GEORGIA DEPARTMENT OF COMMUNITY AFFAIRS

CODE AMENDMENT FORM

CODE: GA Energy Code

PROPONENT: Codes Alliance

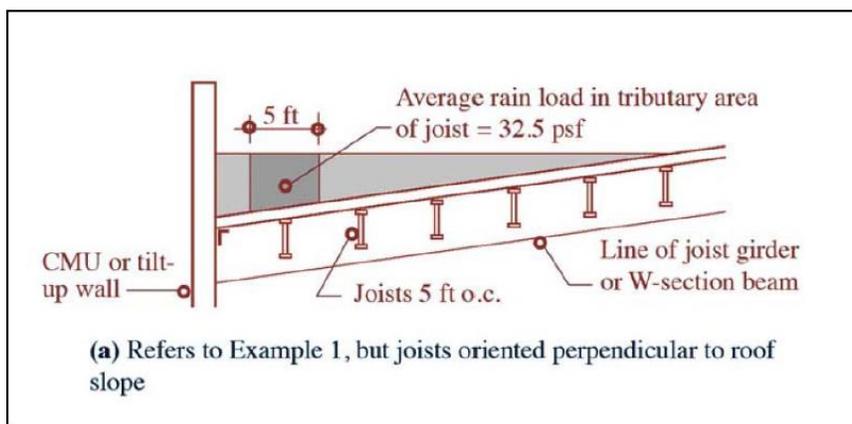
The second major change to codes involves structural requirements for ponding instability. Currently Section 1512.1, Exception 1 allows slopes less than ¼ inch per foot for re-roofing projects. By definition, (IBC Section 202), a *susceptible bay* is “a roof or portion thereof with a slope less than ¼ inch per foot.” Sections 1608.3 and 1611.2 require that *susceptible bays* be evaluated for ponding instability in accordance with Chapters 7 and 8 of ASCE 7. This proposed change allows a slope of less than ¼ inch per foot only if the roof is not susceptible to ponding instability.

ASCE 7-16 significantly revised its “Chapter 8: Rain Loads.” Historically, ASCE and the model codes have required ponding instability to be investigated when a roof slope is less than 1/4 inch per foot. Ponding instability is a serious life-safety and structural issue for roofs. We have also learned that ponding instability is not just an issue on roofs with slopes less than 1/4-inch per foot, but can also an issue on many more roof configurations. In other words, the potential for roof collapse resulting from ponding instability is significant, and many roofs constructed before the 2016 design standards were adopted, have never been analyzed for ponding instability.

The most significant change in the evaluation of ponding instability addressed in ASCE 7-16 is structural orientation. The load on the joists is much greater if the joists are oriented parallel to the wall to which the water drains than if the joists are perpendicular to the wall. Below is example of a collapse in Dallas, TX, where ponding instability and structural orientation was an issue. The accumulation of water on the 1st and 2nd joists that were parallel to the wall was much greater than if the joists had been perpendicular to the wall. This condition resulted in excessive rainwater load on the joists. The photograph below, left shows the roof collapse, and the photograph below, right shows the joists’ structural orientation.

Figure 1. (Lstiburek, J.W.)

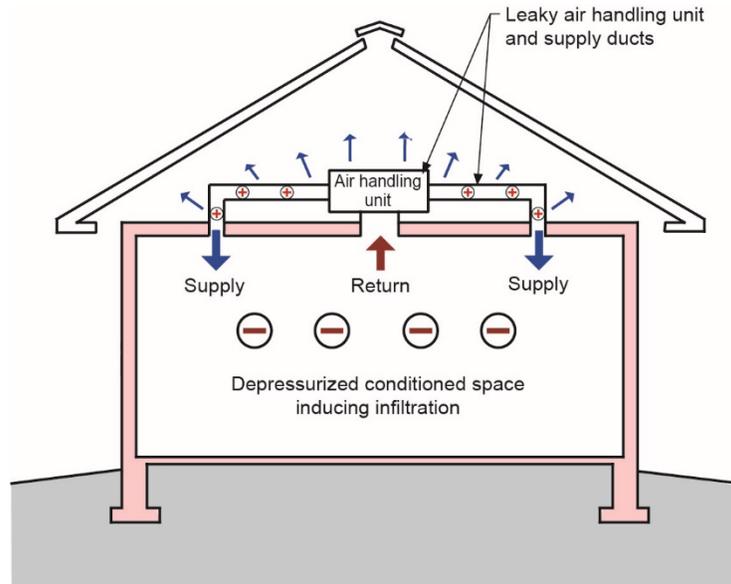
- **Airtightness.** a house that has a conditioned unvented attic can be significantly more airtight than houses without it thus making it more energy efficient. Even though the model code has requirements for duct tightness levels the ductwork and air handlers are often leaky. Often the ductwork and/or the air handlers are located in the attic, if the attic is conditioned the leaks will not have a big energy penalty, if the attic is unconditioned and vented the leaks from these systems can result in a pressure difference causing more infiltration into the home. Figure 1, below outlines this issue.

Figure 2. (Ueno, K and Lstiburek, J.W)

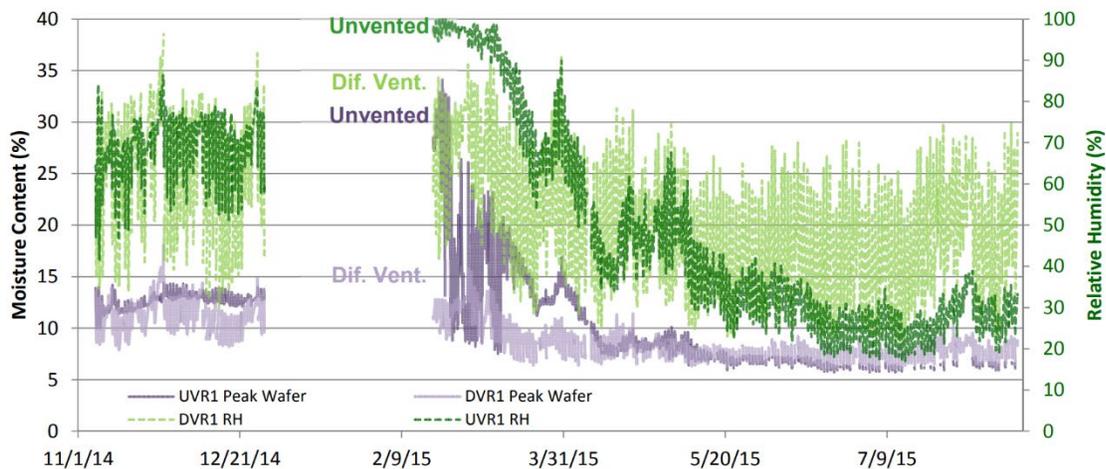
- **Moisture Control in Humid Climates.** The traditional way of thinking is that vented attics help to alleviate moisture issues and this may be true in certain climate zones. In a hot humid climate having a vented attic will cause moisture problems, it will bring the hot humid air from outside the home into the attic which causes ductwork to sweat which in turn can cause moisture and mold growth on sheathing and framing. The alternative is unvented attics, these attics have shown to have some moisture concerns as well near the ridge, however, the introduction of vapor diffusion ports has shown to significantly reduce the moisture build up in these area to help to alleviate moisture build up. The difference in moisture is shown below.

Figure 1. (Lstiburek, J.W.)

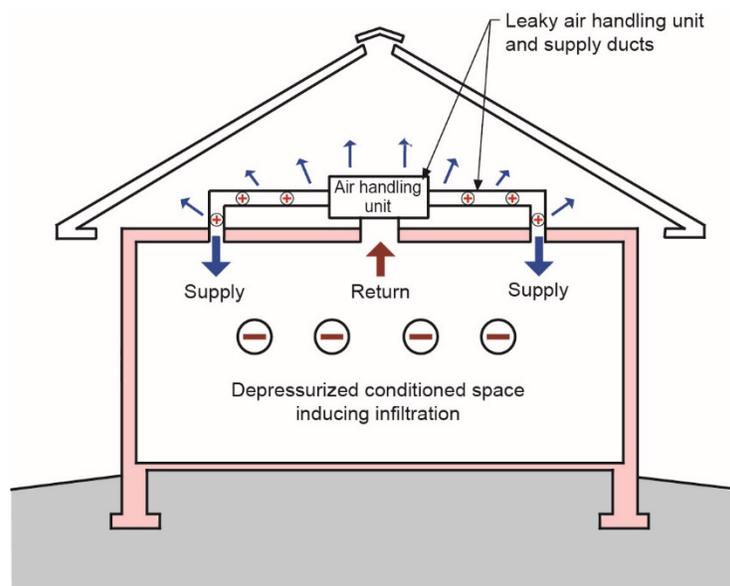
- **Airtightness.** a house that has a conditioned unvented attic can be significantly more airtight than houses without it thus making it more energy efficient. Even though the model code has requirements for duct tightness levels the ductwork and air handlers are often leaky. Often the ductwork and/or the air handlers are located in the attic, if the attic is conditioned the leaks will not have a big energy penalty, if the attic is unconditioned and vented the leaks from these systems can result in a pressure difference causing more infiltration into the home. Figure 1, below outlines this issue.

Figure 2. (Ueno, K and Lstiburek, J.W)

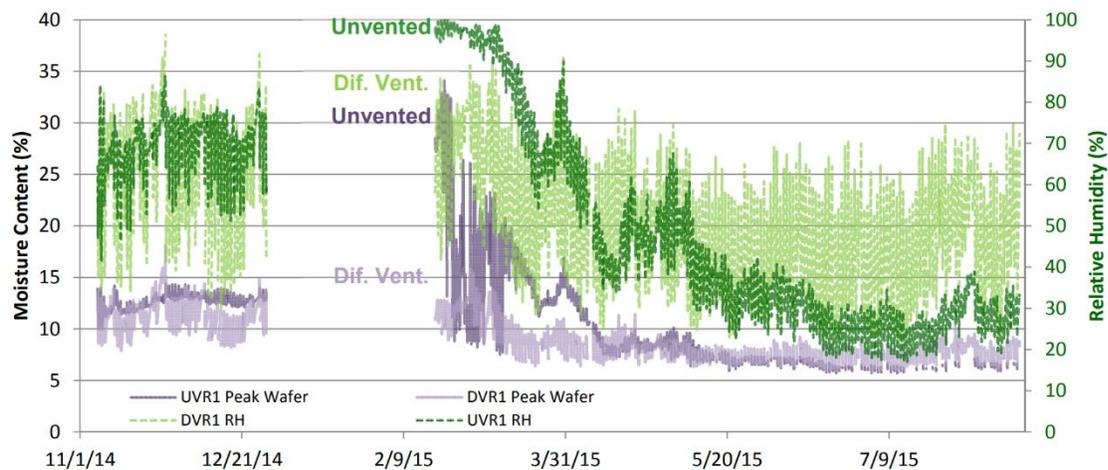
- **Moisture Control in Humid Climates.** The traditional way of thinking is that vented attics help to alleviate moisture issues and this may be true in certain climate zones. In a hot humid climate having a vented attic will cause moisture problems, it will bring the hot humid air from outside the home into the attic which causes ductwork to sweat which in turn can cause moisture and mold growth on sheathing and framing. The alternative is unvented attics, these attics have shown to have some moisture concerns as well near the ridge, however, the introduction of vapor diffusion ports has shown to significantly reduce the moisture build up in these area to help to alleviate moisture build up. The difference in moisture is shown below.
